## NC Wall Bracing Proposal for Permanent Rule – Rules Commission Submittal - 01/04/13

### **Explanation of proposal:**

**Figure R602.10.1**  
**Method PF – Portal Frame Construction**

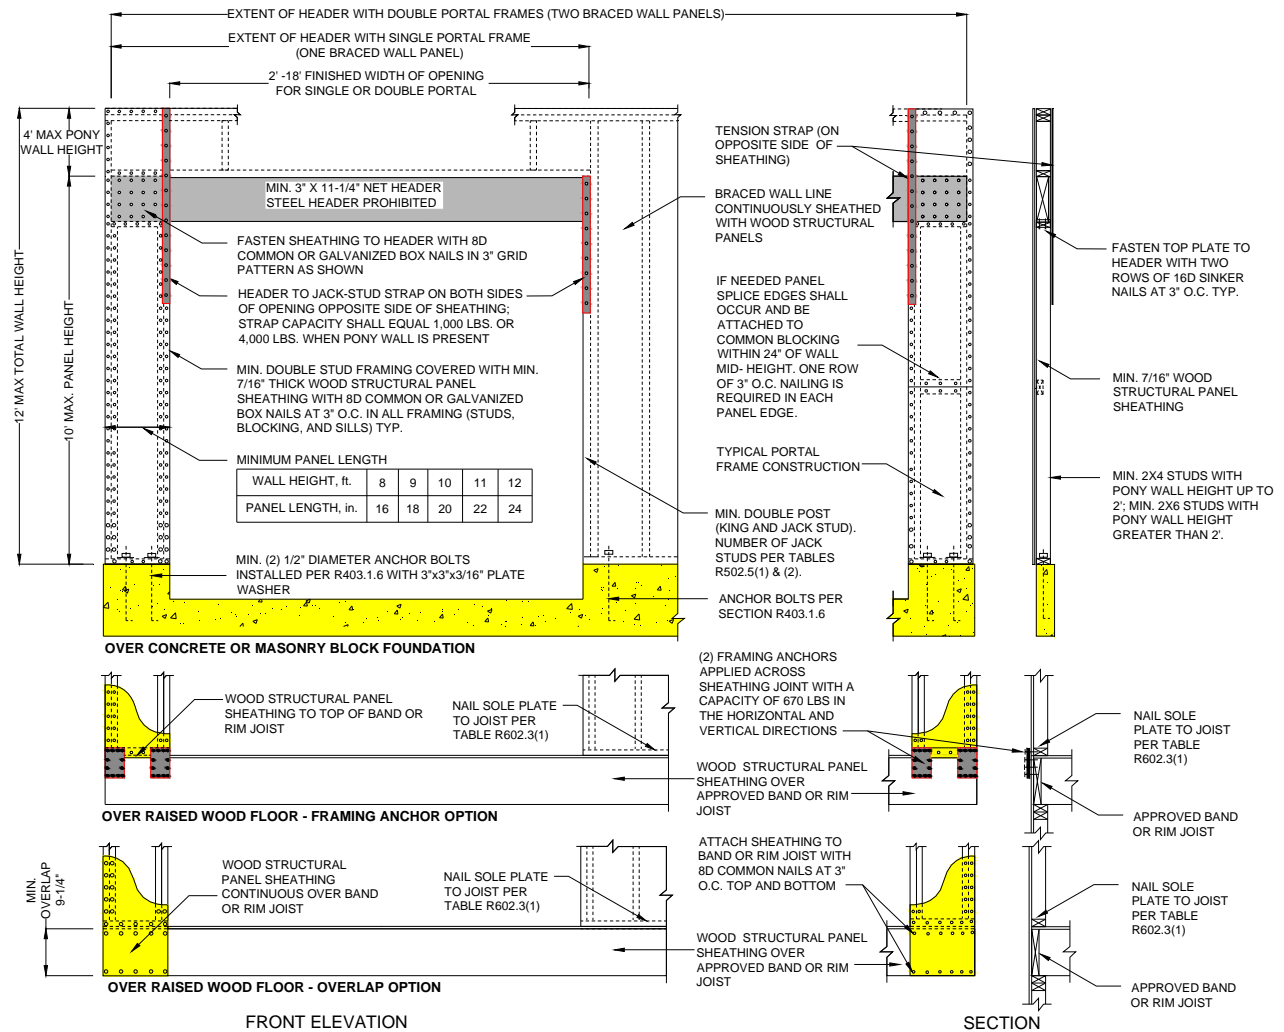
**ICC Staff: On middle illustration above remove the word "VERTICAL" from the note referring to the (2) framing anchors.**

**FIGURE R602.10.5.3**  
**MASONRY STEM WALLS SUPPORTING BRACED WALL PANELS**

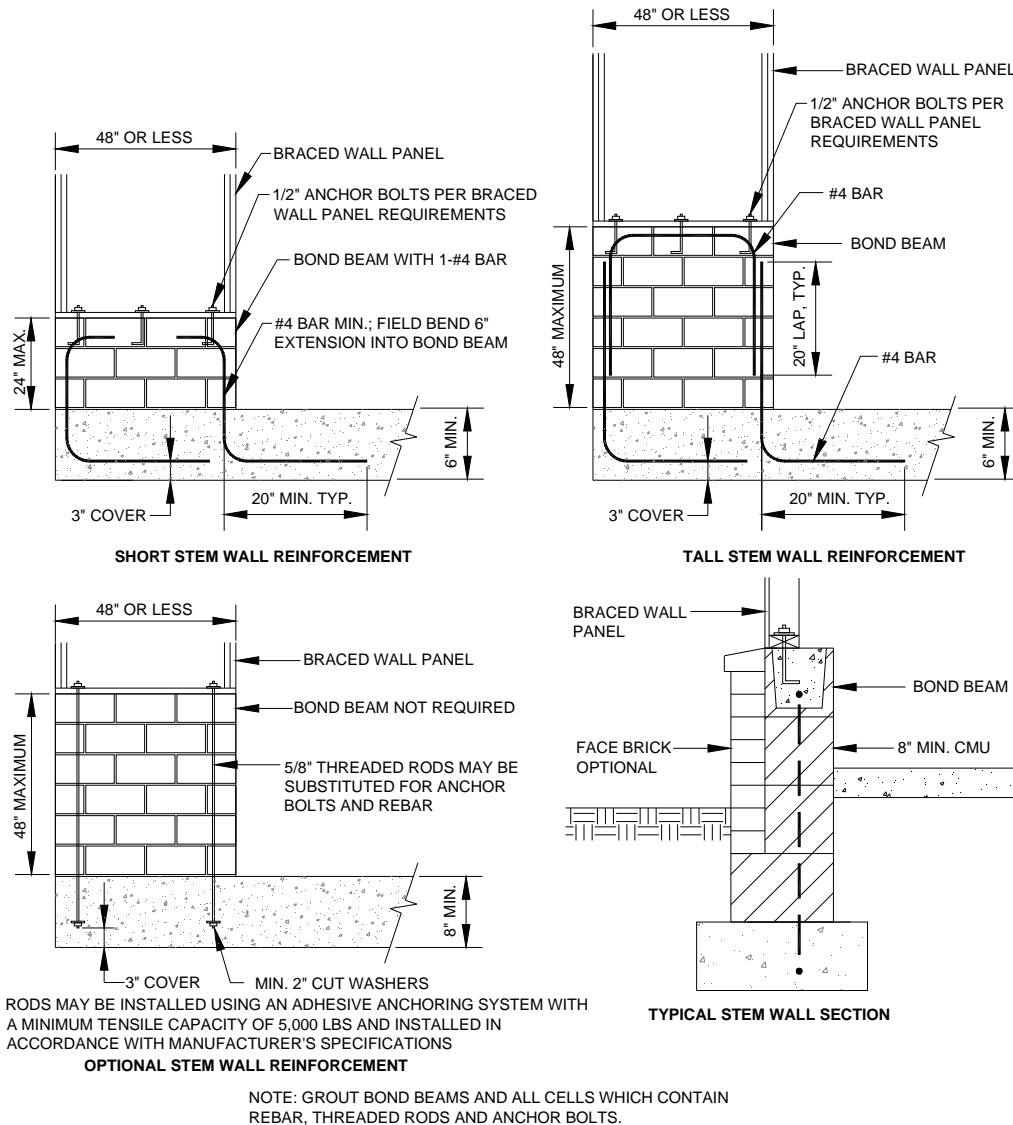
**ICC Staff: In the lower left diagram change 5/8" threaded rods to 1/2" threaded rods, and change adhesive capacity from 5000 lbs. to 3750 lbs.**
